**UNITED STATES ENVIRONMENTAL PROTECTION AGENCY
NEW ENGLAND REGION
FIVE POST OFFICE SQUARE, SUITE 100, BOSTON, MA 02109**

Re: Approval of de maximis inc. report titled *Remedial Design Work Plan – Appendix E In Situ Sequestration Treatability Study Work Plan* (the “TSWP”), dated September 2020.

Nuclear Metals, Inc. Superfund Site

Response To Comments

6

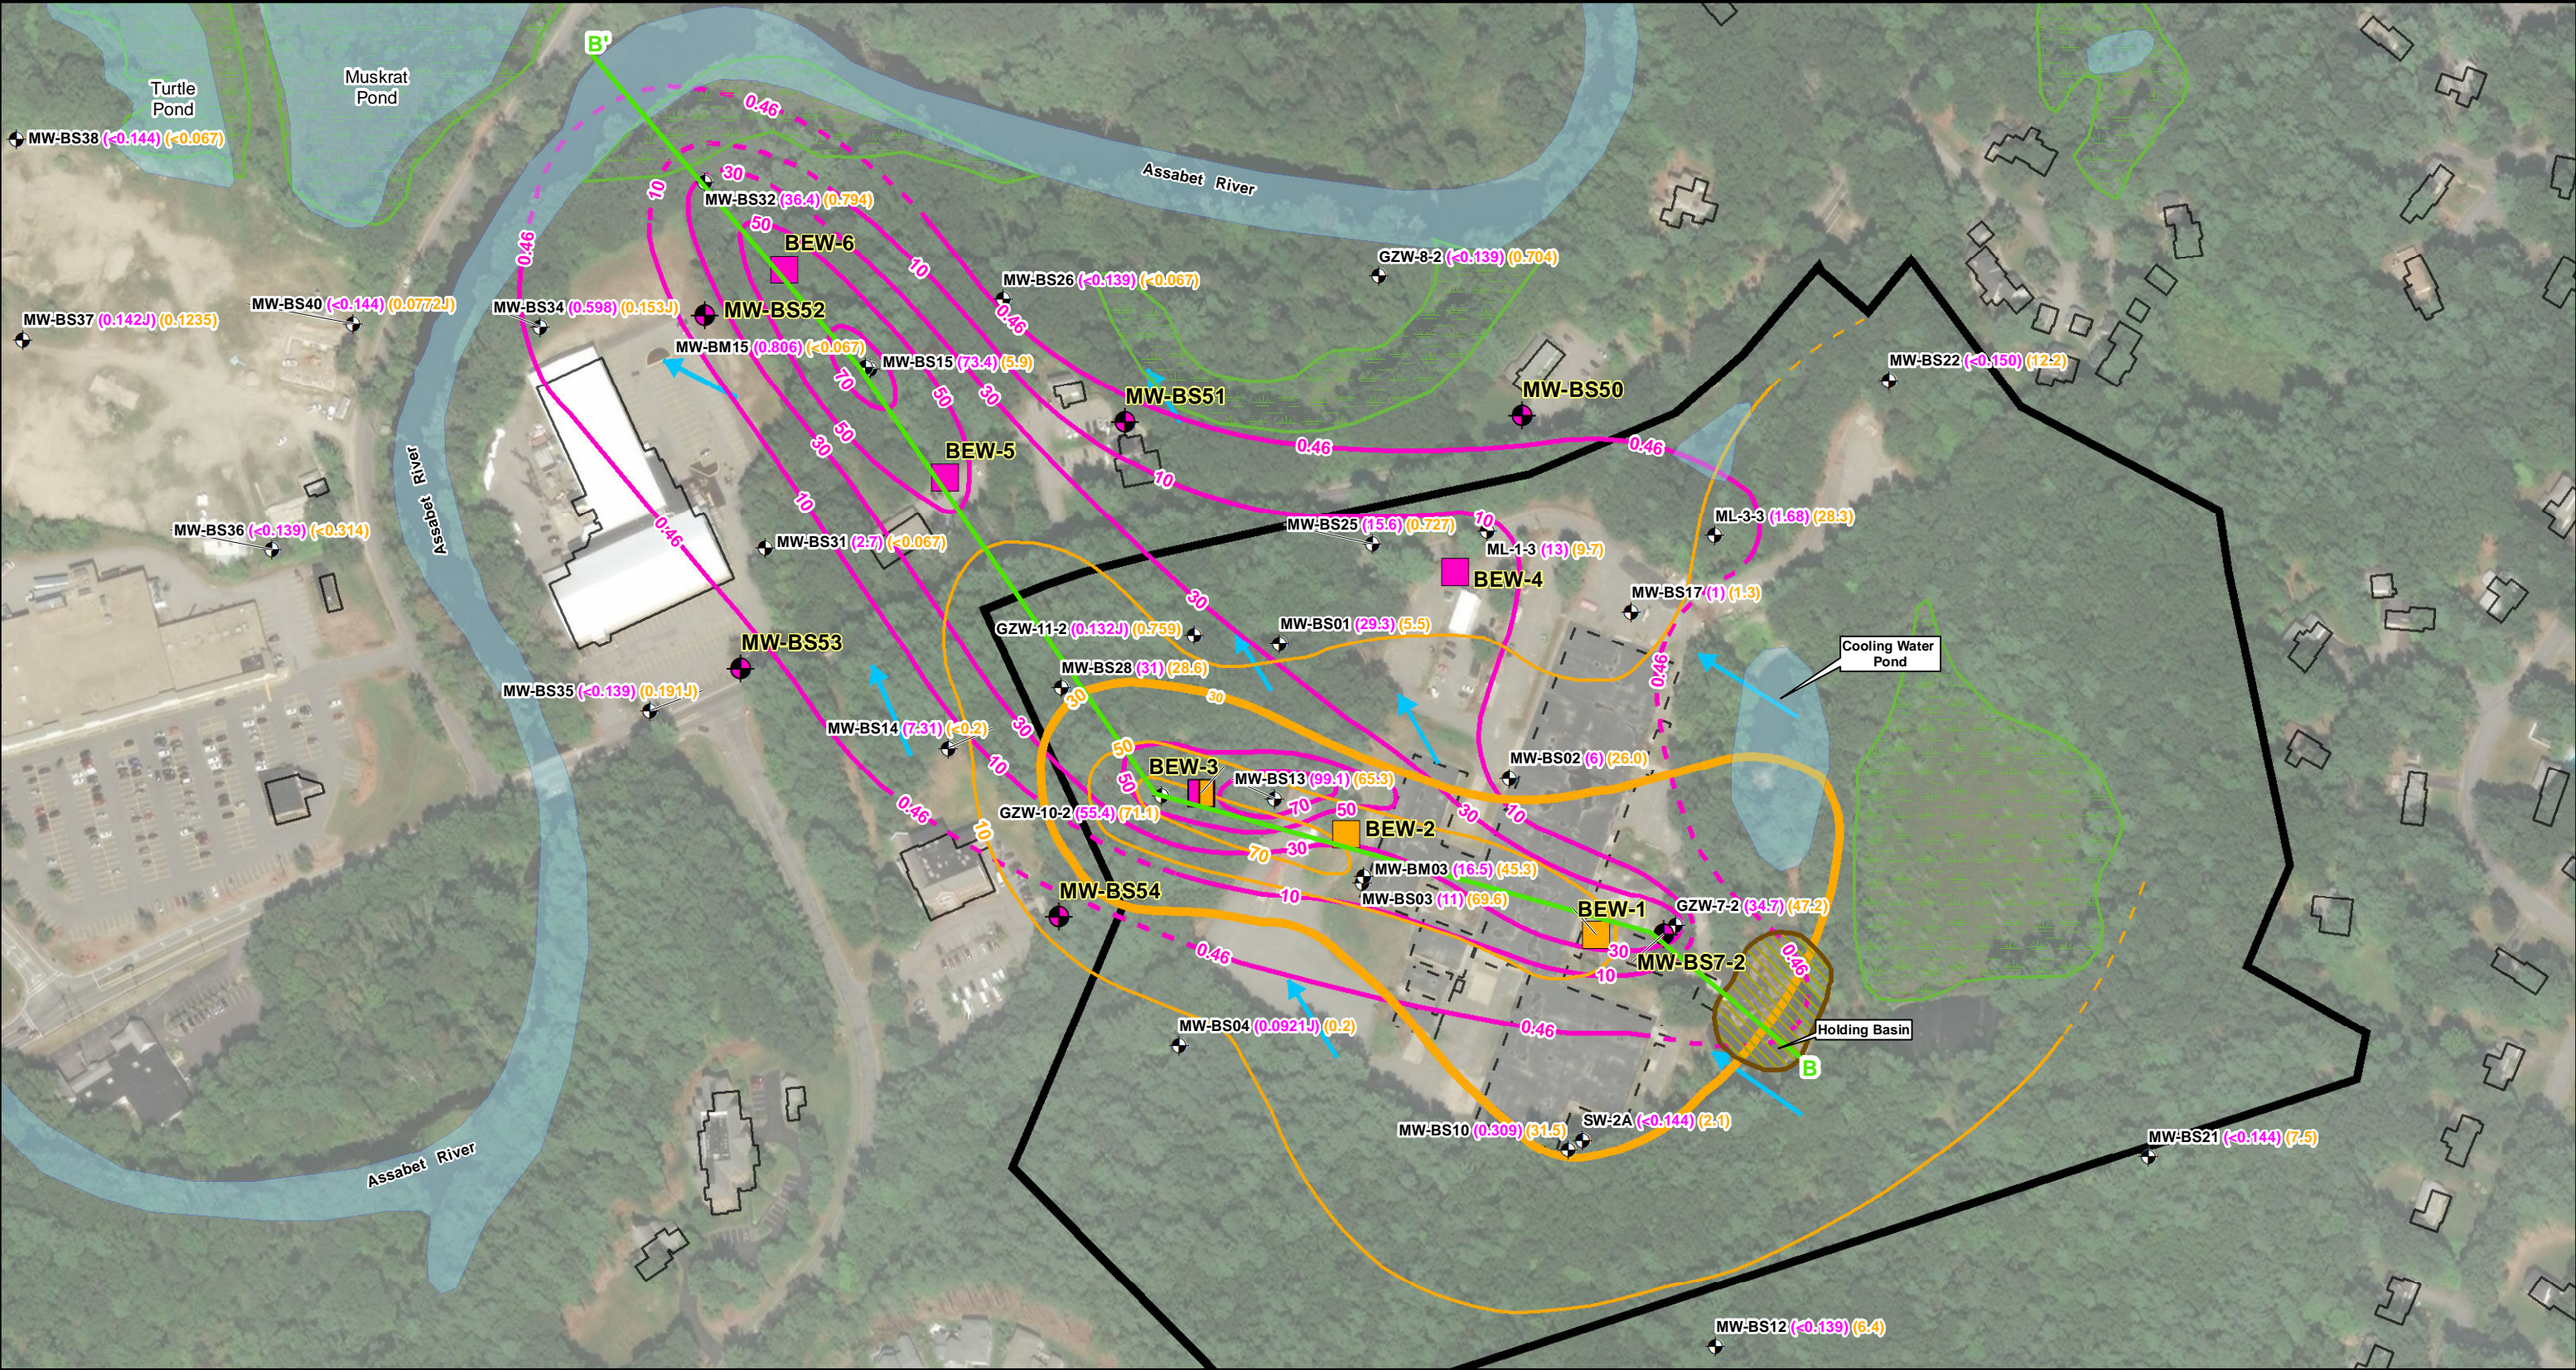
In the past, a figure has been presented with the historical U concentrations in bedrock wells. Figure 2-7.1 has been updated with historical and recent bedrock data and is attached. During preparation of this figure, the November 2019 data were revisited, and we felt that it would be appropriate to expand the 70 µg/L U contour eastward in the area near GZW-10-2, MW-BS-13, and MW-BS03. Revised RDWP Figure 6b, Appendix B Figures 2-7, 3-3, and 3-4; RDWP Appendix D Figures 6, 7, and 9 incorporate this change, and are attached.

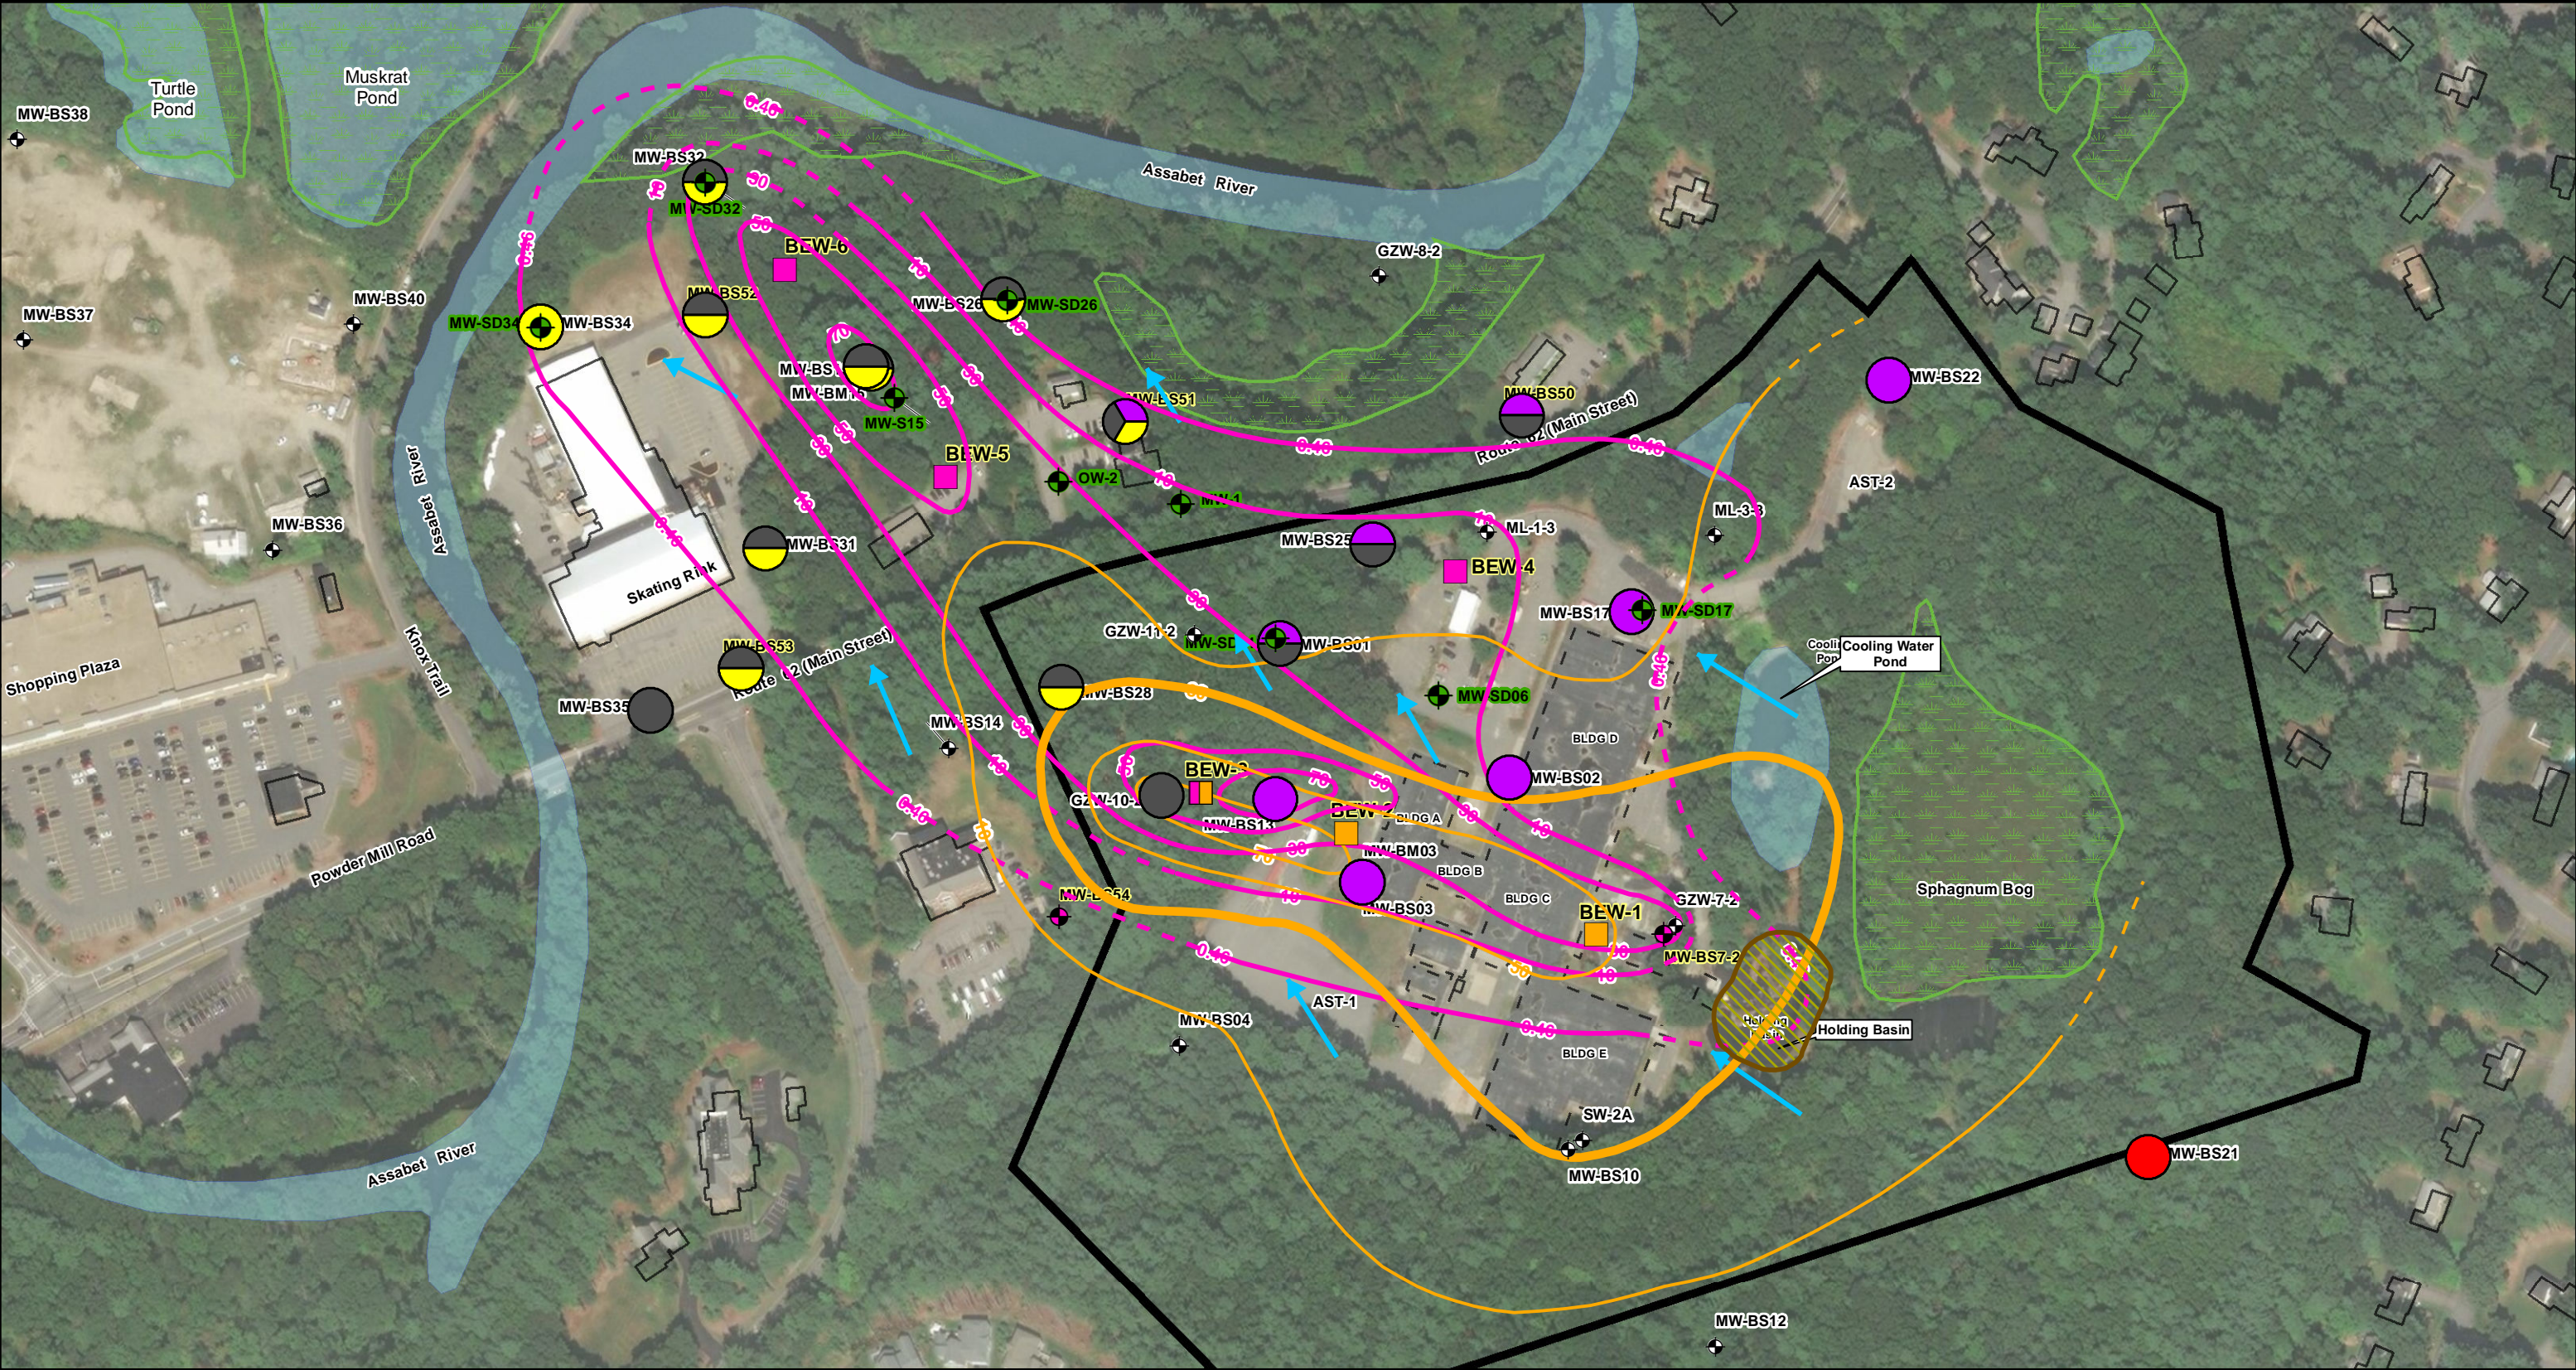
13. **Figure 9.** The legend is missing descriptions for some of the symbols. Please revise the legend as appropriate.

FIGURE 2

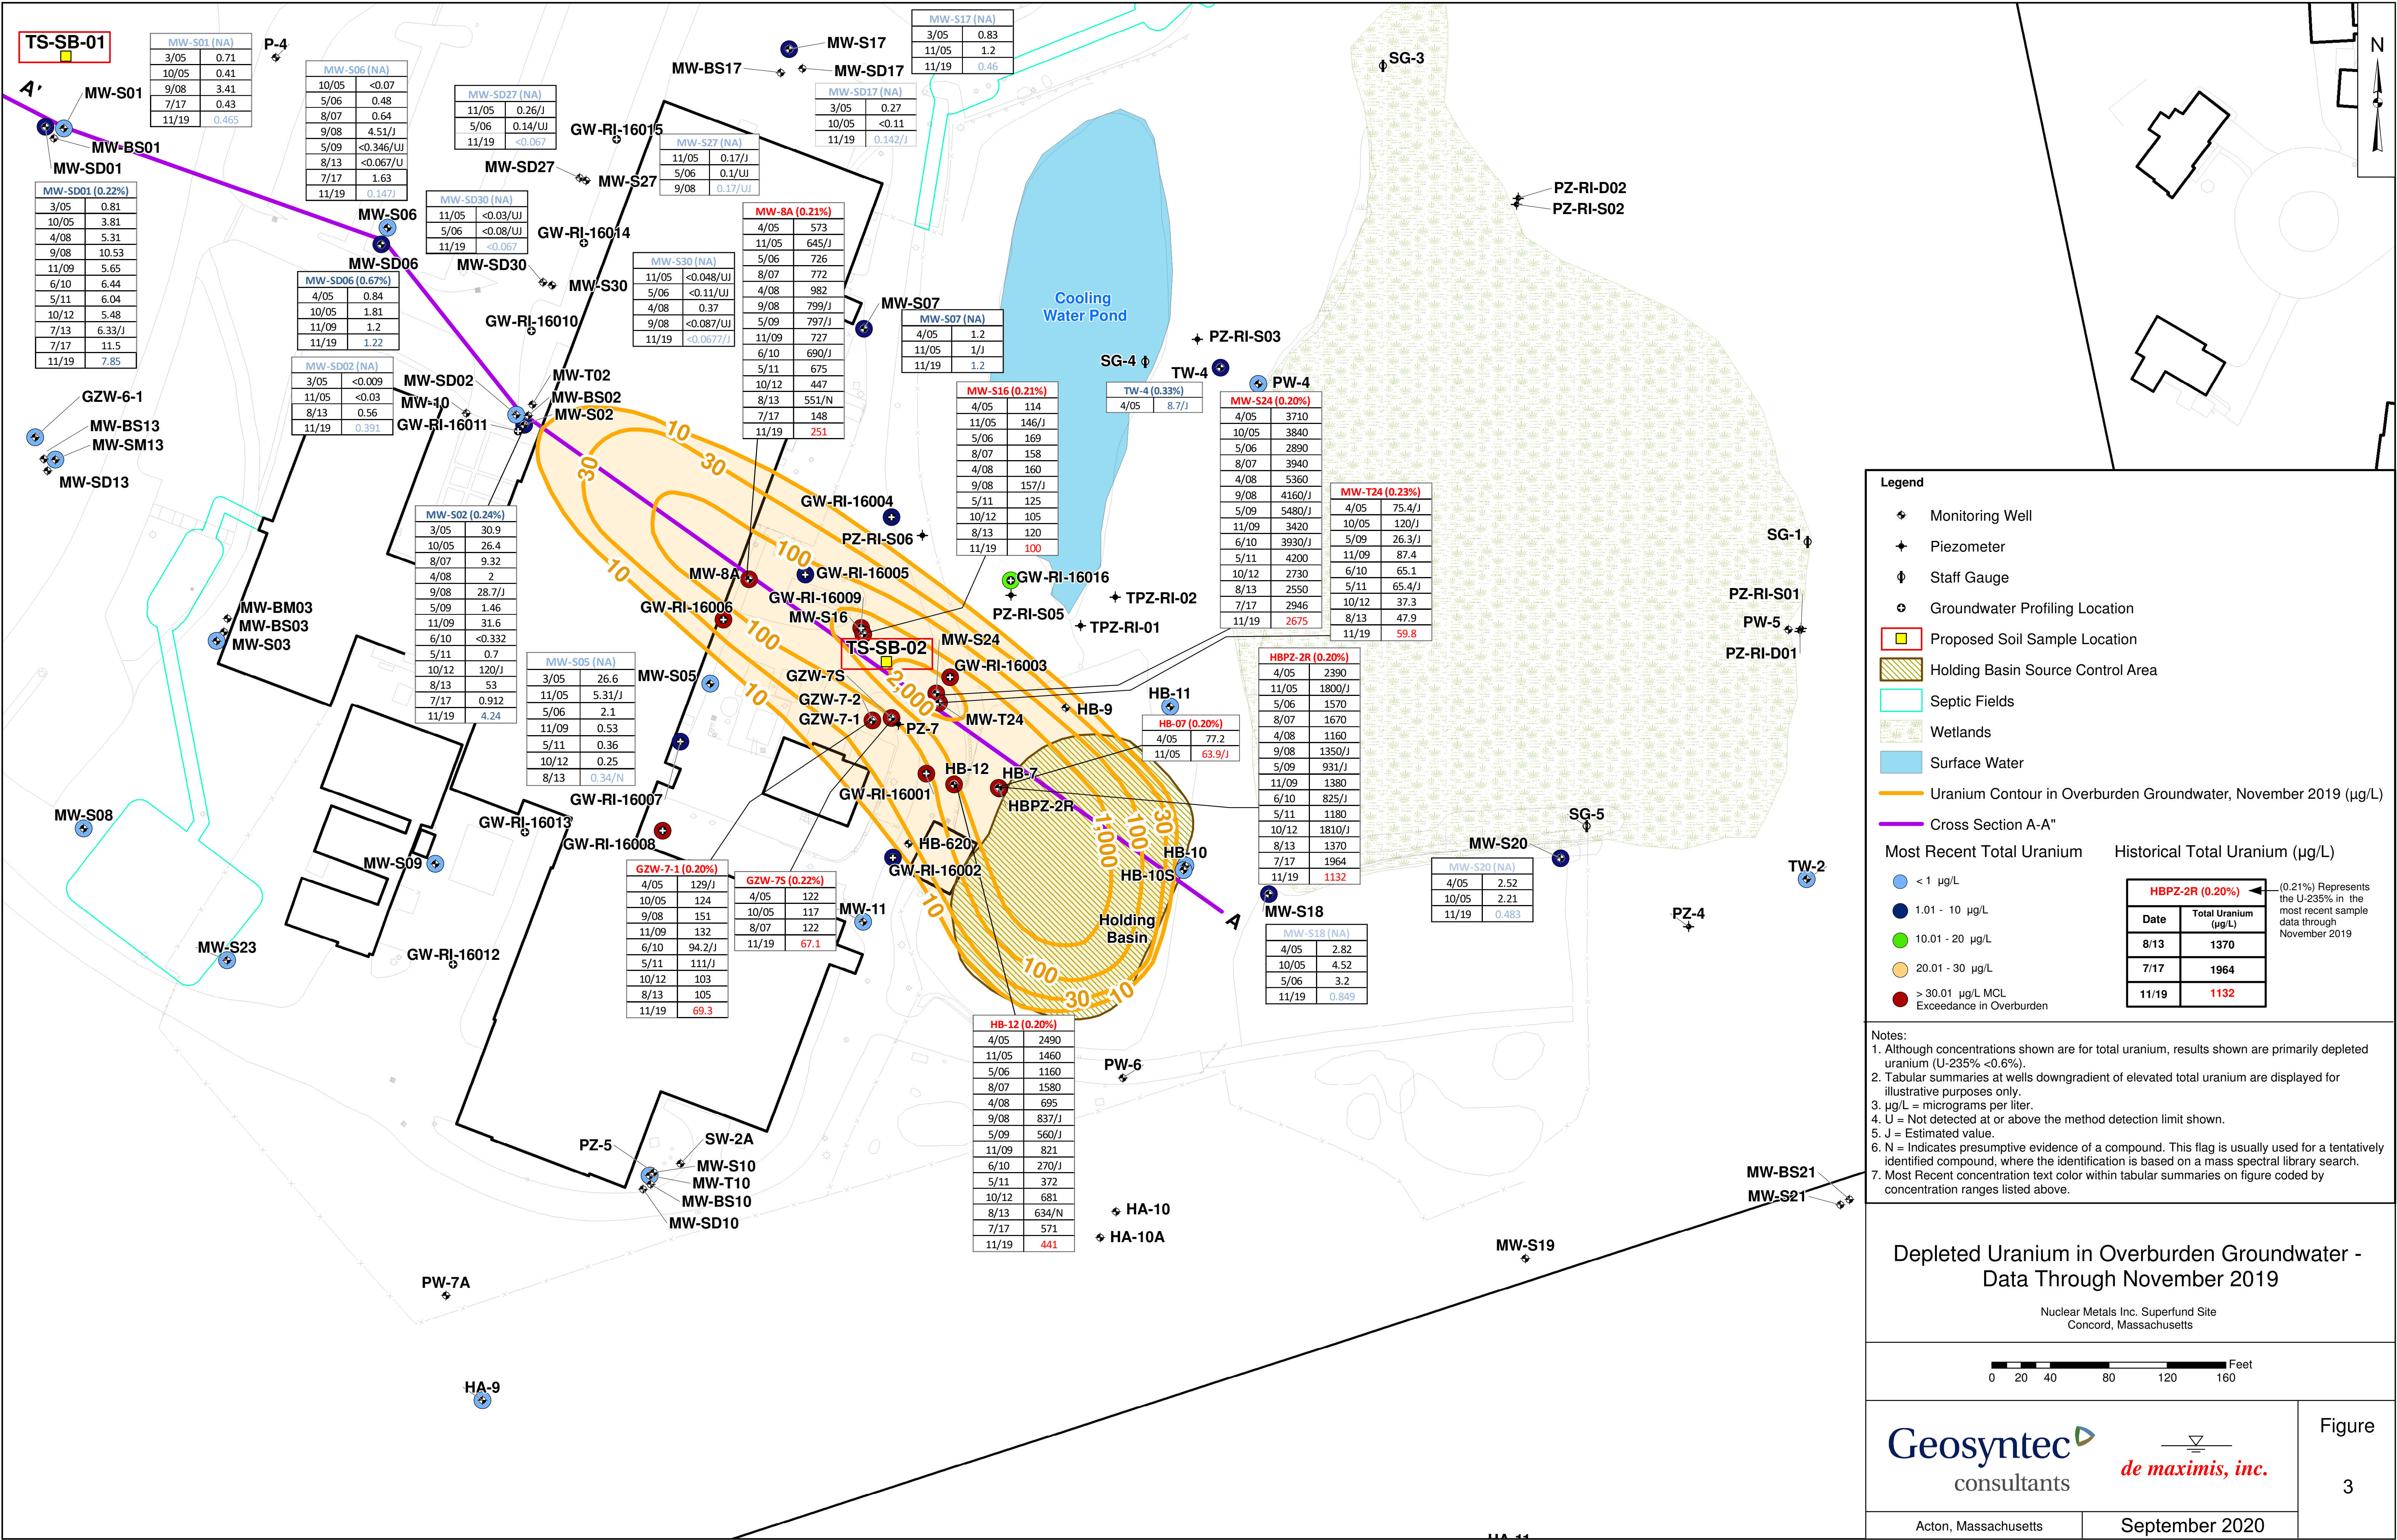
4. If the soil core is collected above the target sample interval for that location (Figure 2), a maximum of one, 1-L subsample per 5 feet may be collected from the portion of the core exhibiting the highest radiological activity and submitted to the on-site laboratory for analysis. The remaining soil will be set aside until the on-site laboratory results are received.

8. Soil borings in the saturated and unsaturated zones shall be advanced following the order identified on **Figure 2**. The drill tooling will be decontaminated between each boring following the procedures outlined in the decontamination standard operating procedure (SOP) (NMI-007, in the Field Sampling Plan [FSP]). After receiving the on-site laboratory results for samples from the three primary borings, the total volume of the subsamples with uranium concentrations greater than 100 mg/kg in each saturation zone shall be measured. If the total volume exceeds 30 L, those samples shall be submitted to the treatability testing laboratory. If less than 30 L of soil with uranium concentration greater than 100 mg/kg have been collected, then additional borings shall be advanced at the secondary locations identified in **Figure 2** or as step-outs from the primary borings with known elevated uranium concentration. This additional sampling shall follow the same procedure described above until a total of 30 L of soil with uranium concentrations greater than 100 mg/kg have been collected from the saturated and unsaturated zones combined.
